Subject: N222391310 - Service Update  
Torque Converter Housing Access Hole Cover Not Installed

Models: 2023 Chevrolet Silverado 2500HD/3500HD  
2023 GMC Sierra 2500HD/3500HD  
Equipped with TRANSMISSION-AUTO 10 SPD, 10L1000, GRX, GEN  
1, VAR 1 (RPO MGM)

# Service Update

## N222391310 Torque Converter Housing Access Hole Cover Not Installed

6281257

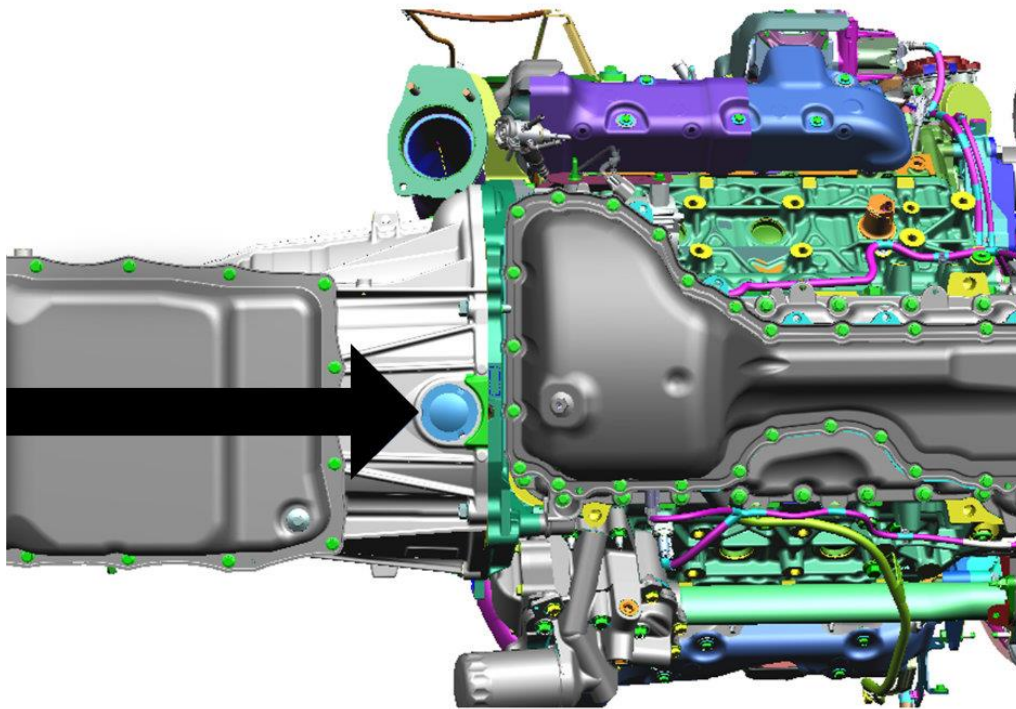
<b>Condition</b>	Certain 2023 model year Chevrolet Silverado 2500HD/3500HD and GMC Sierra 2500HD/3500HD vehicles, may have a condition in which the torque converter housing access hole cover was not installed.
<b>Correction</b>	Dealers are to install the torque converter housing access hole cover.

2. Snap the torque converter housing access hole cover into the inspection port located on the underside of the bellhousing, indicated by the arrow above.
3. Lower the vehicle. Refer to *Lifting and Jacking the Vehicle* in SI.
